1964 Corvette: Service Bulletin: Directional Signal Switch Service

Model Year: 1964 All Series Except Corvette and Comfortilt Wheel Subject: Directional Signal Switch Service Source: Chevrolet - Central Office - Technical Service Bulletin Bulletin No: DR #693, Section XII Date: September 8, 1964

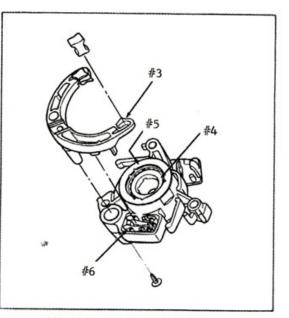
- 1. Diagnose the problem as one that involves the directional signal switch, and eliminate other possible causes before removing the steering wheel (See attached "Trouble Shooting" guide).
- 2. Disconnect battery and remove the steering wheel per Shop Manual Instructions. On Chevelle Models, remove the retainer, spring and cancelling cam.
- 3. Remove the directional signal operating lever.
- 4. Remove the three (3) switch retaining screws and lift the switch enough to disengage the shifter tube housing.

5. Follow shop manual procedures of disassembly until the switch harness can be pulled out far enough to gain access to the actuating plate screw and remove the screw and actuating plate.

Any of the following components may be replaced without complete switch replacement; cancelling cam, actuating plate, upper mast jacket bearing and contactor kit.
